From: [Ryan Nehls](#)
To: [Koepeke, Cynthia L - DNR](#)
Cc: [Bill Buckingham](#); [Brian Flad](#)
Subject: Shorewood Commons BRRS #02-13-560698
Date: Friday, June 24, 2022 11:41:03 AM
Attachments: [HydroGraph.pdf](#)
[Well Screen & Water Levels.pdf](#)
[Site Map.pdf](#)

GROUNDWATER ELEVATION MAP (5/20/22)
 PHASE II INVESTIGATION
 SHOREWOOD COMMONS
 3330 UNIVERSITY AVENUE
 SHOREWOOD, WI 53705

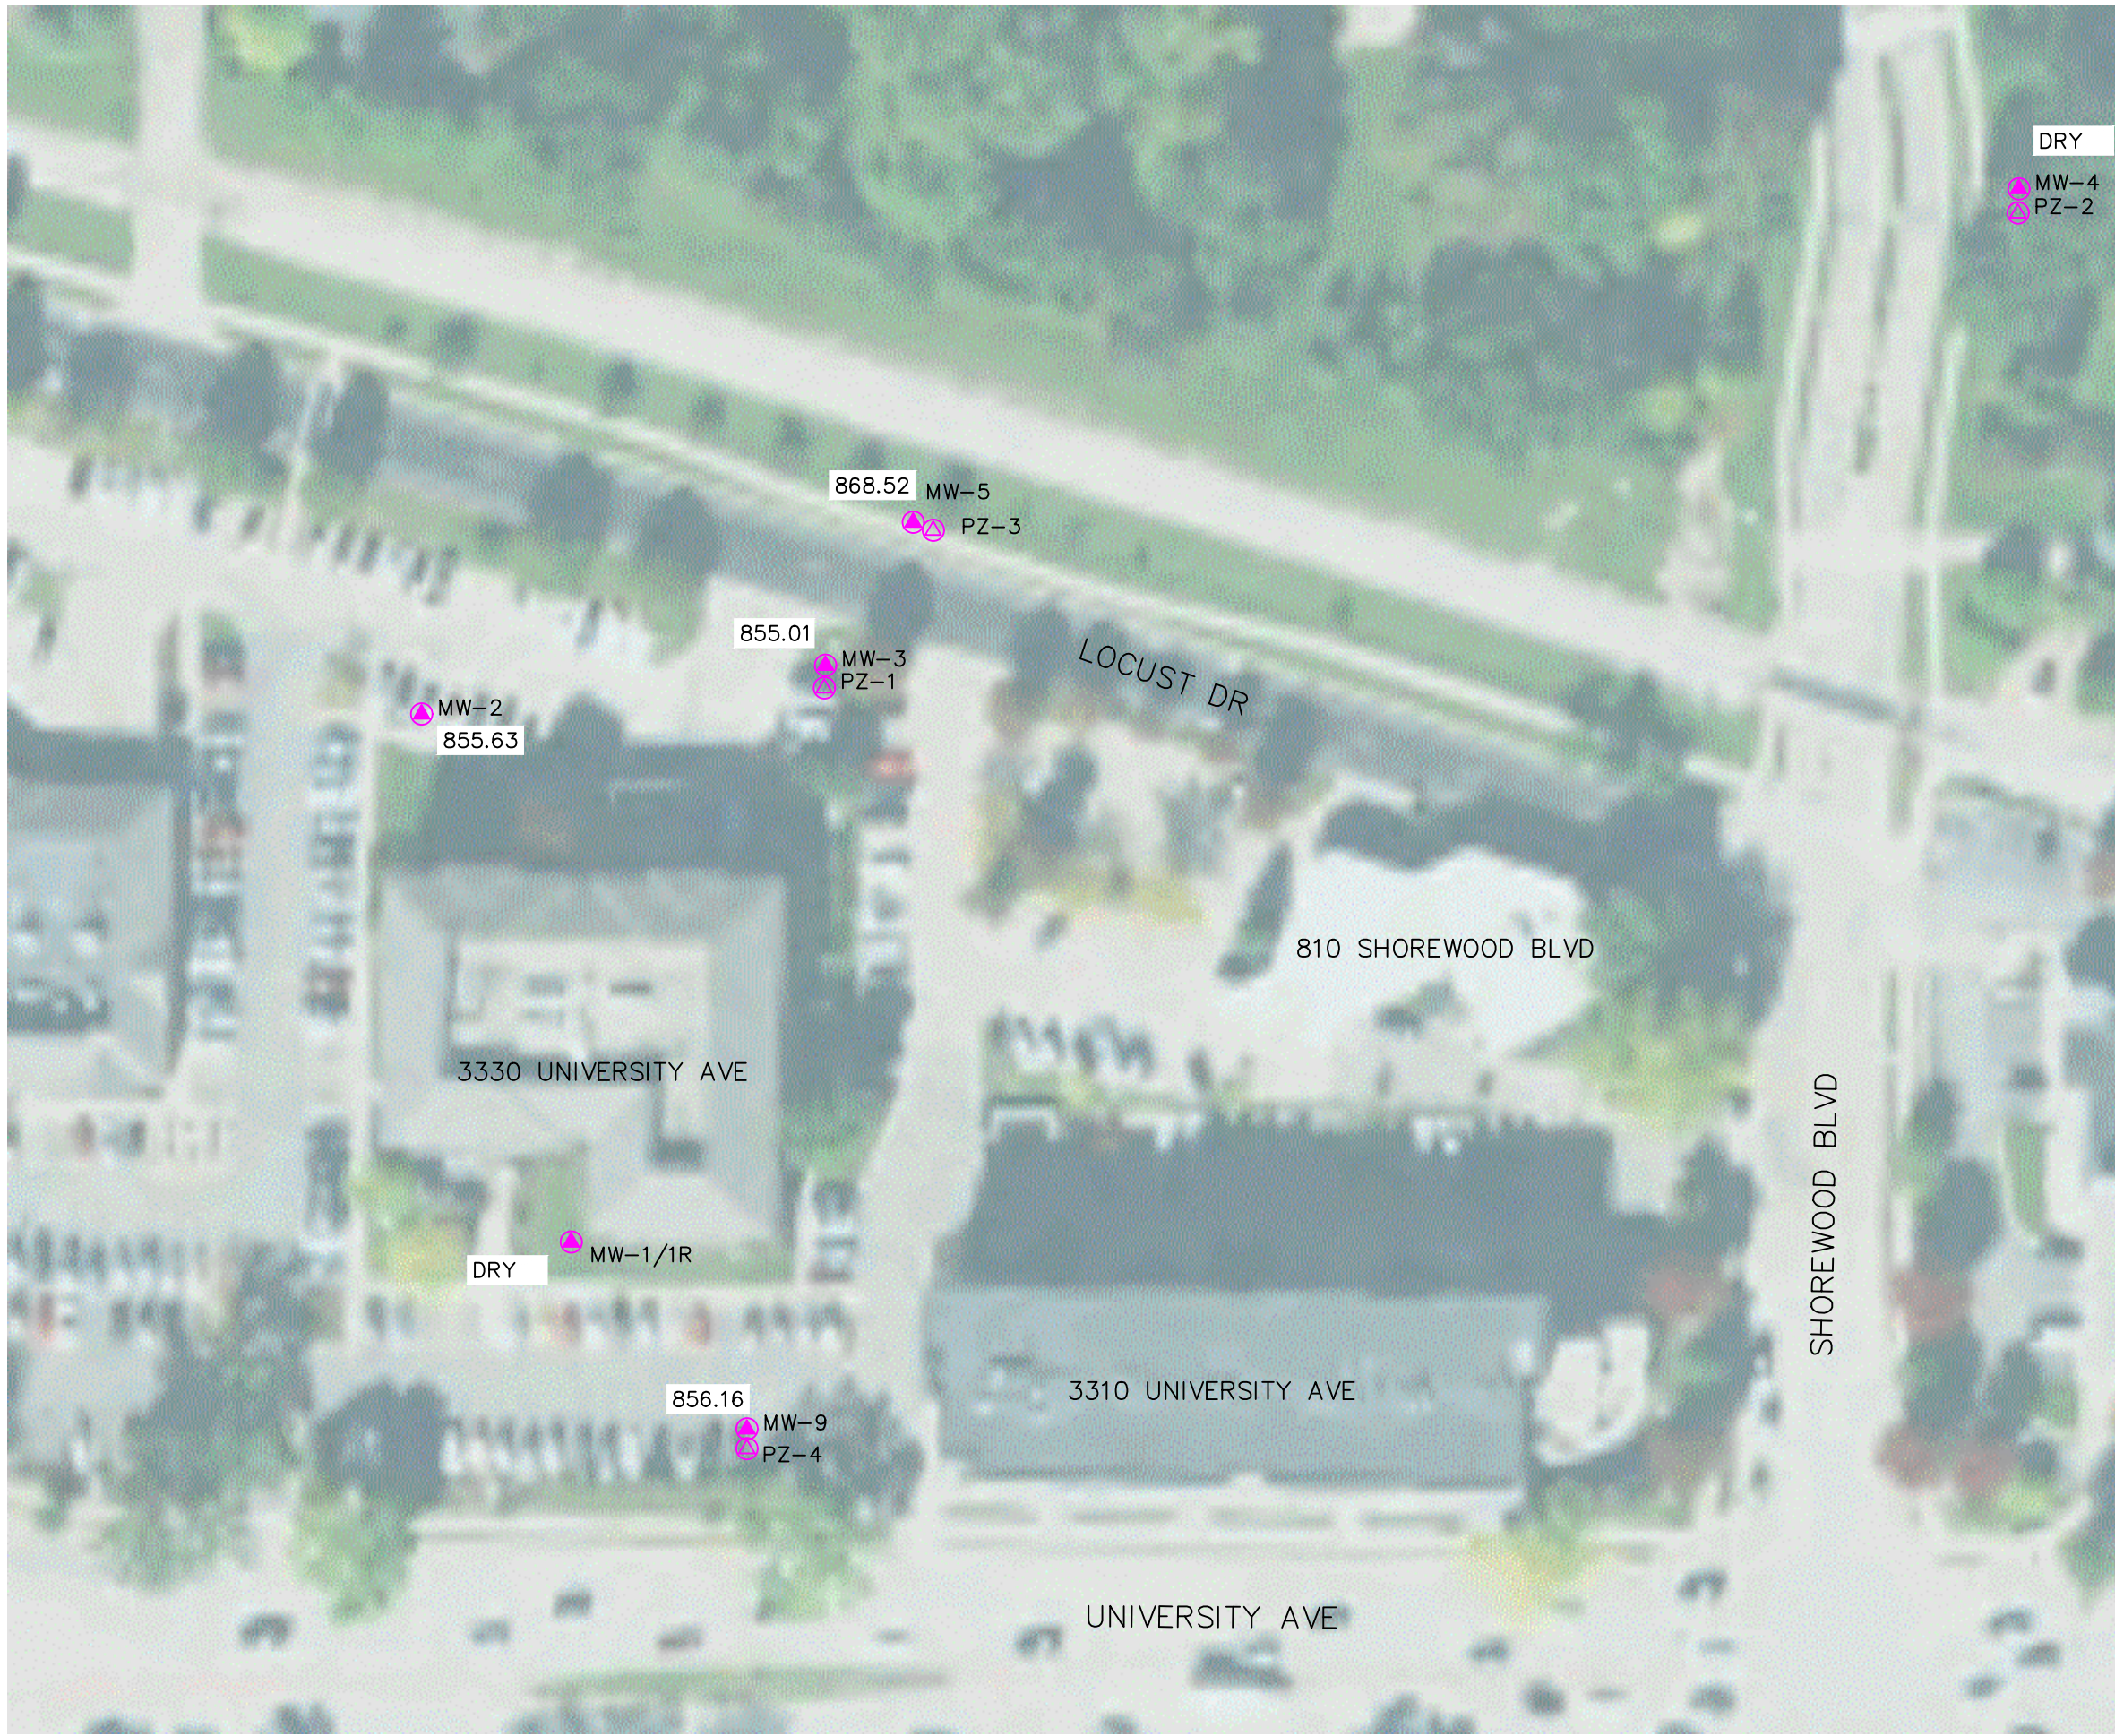
We measured groundwater levels on 1/18/22 and 5/20/22. In January, it appeared the water level was equalizing a bit in our new MW-5 but unfortunately the water level rose 5' in May (while other wells dropped ~12"). I put together some hydrographs and responses to your comments from your 2/18/22 email can be found in red below:

Well Screens & Water Elevation

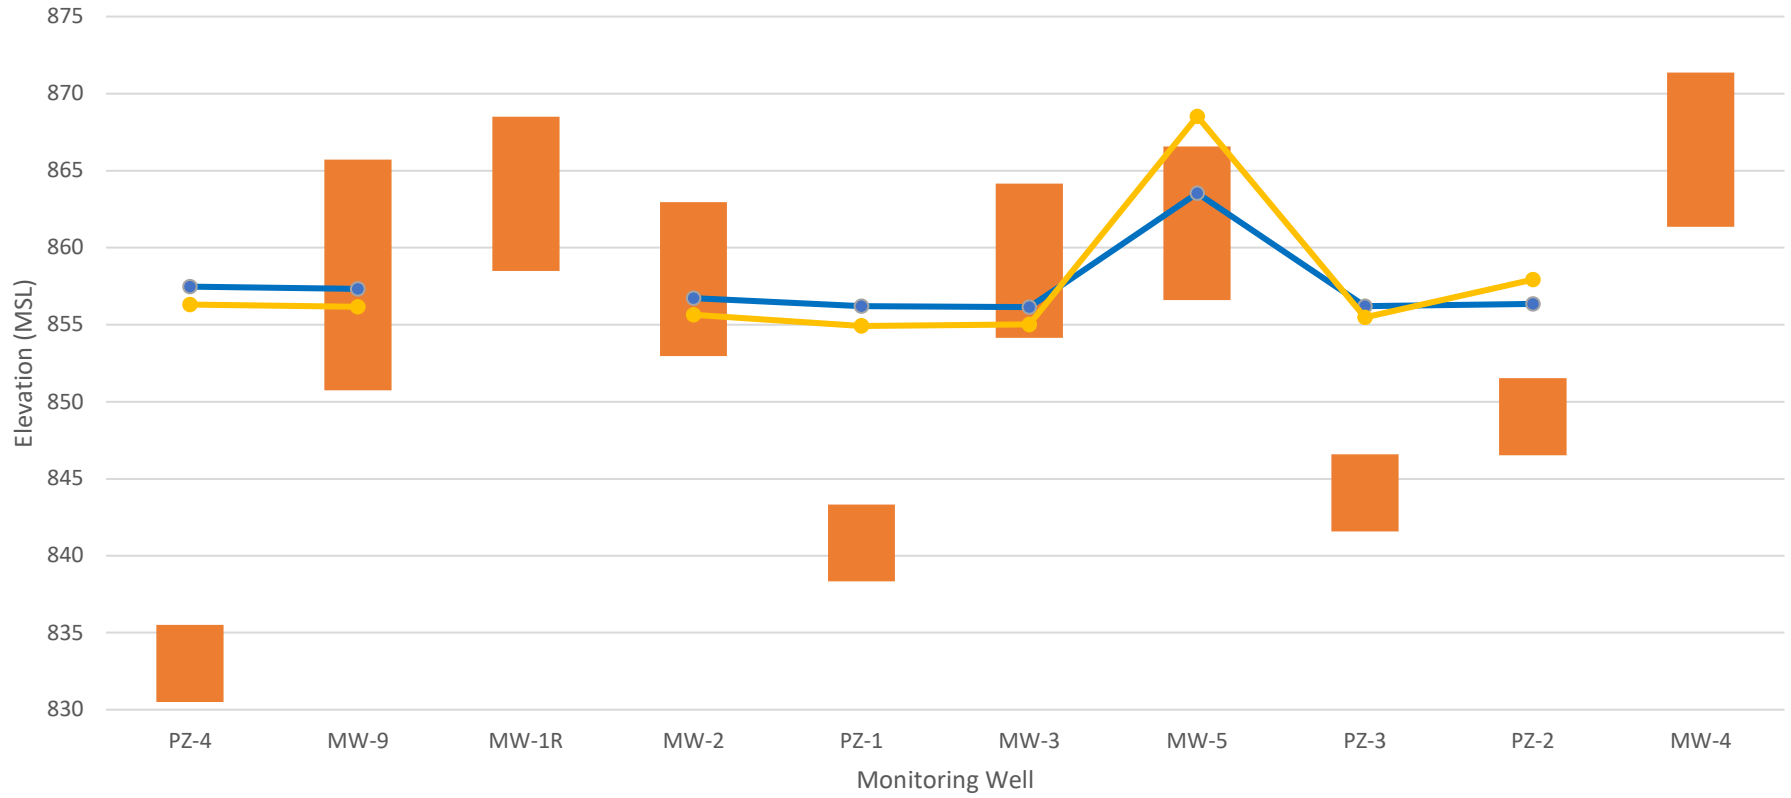
2. Some cross-sections and a chart showing the well screen depths can help show if the wells might be in different units with different hydraulic conductivities or with the screen submerged etc.
See attached Well Screen & Water Levels. The wells are ordered in what is assumed upgradient to downgradient. We're below the screens on MW-1R and MW-4.
